Access Compliance Report

Public Rights-of-Way

Intersection ID: 14949	Main Street: CAMPBELL_DR	Cross Street: DRIFTWOOD_DR	Location: NW
ADA ID: 9FE9641C8F86	Ramp Type: ParaDiag	Initial Pass/Fail: Fail	Overall Compliance: No
		Severity Score: 22.5

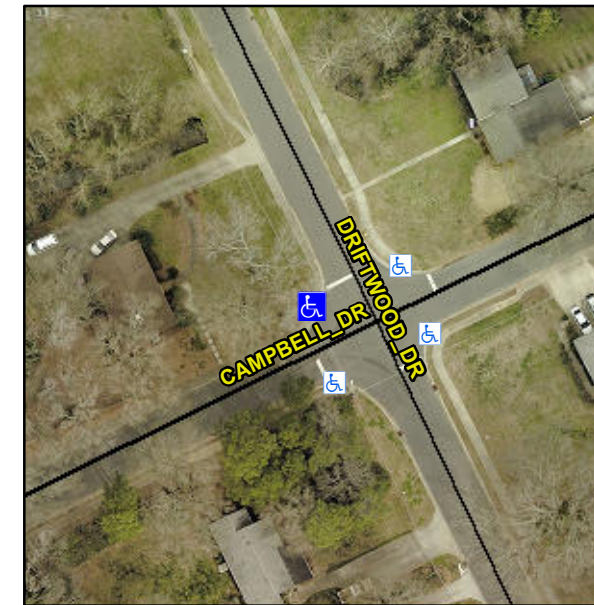
R304.5.1, R304.3.2, R304.5.3

Compliance	Description	Data	Compliance	Description	Data
N/A	Ramp Length LT (in)	110.0	N/A	Ramp Length RT (in)	64.0
No	Ramp Width LT (in)	46.0	Yes	Ramp Width RT (in)	49.0
No	Ramp Slope LT (%)	9.1	No	Ramp Slope RT (%)	10.0
Yes	Ramp XSlope LT (%)	1.4	No	Ramp XSlope RT (%)	2.2
N/A	Landing Length (in)	N/A	N/A	DWS Provided?	N/A
N/A	Landing Width (in)	N/A	N/A	DWS Contrast?	N/A
N/A	Landing Slope (%)	N/A	N/A	DWS Length (in)	N/A
N/A	Landing X Slope (%)	N/A	N/A	DWS Full Width?	N/A
N/A	Landing Curb? (Y/N)	N/A	N/A	DWS Offset (in)	N/A
N/A	Shared Landing?	N/A			
N/A	Gutter Ponding?	N/A	N/A	Gutter Slope (%)	N/A
N/A	Gutter Lip Ht (in)	N/A	N/A	Gutter X Slope (%)	N/A
N/A	Painted X Walk1?	No	N/A	Painted X Walk2?	No
	X Walk 1 Direction	To S		X Walk 2 Direction	To E
N/A	X Walk 1 Width (in)	N/A	N/A	X Walk 2 Width (in)	N/A
	X Walk 1 Slope (%)	7.2		X Walk 2 Slope (%)	3.5
	X Walk 1 X Slope (%)	1.1		X Walk 2 X Slope (%)	11.5
N/A	Ramp inside XWalk1?	N/A	N/A	Ramp inside XWalk2?	N/A

Remove & Replace Curb Ramp With Two New Directional Ramps or Equivalent.
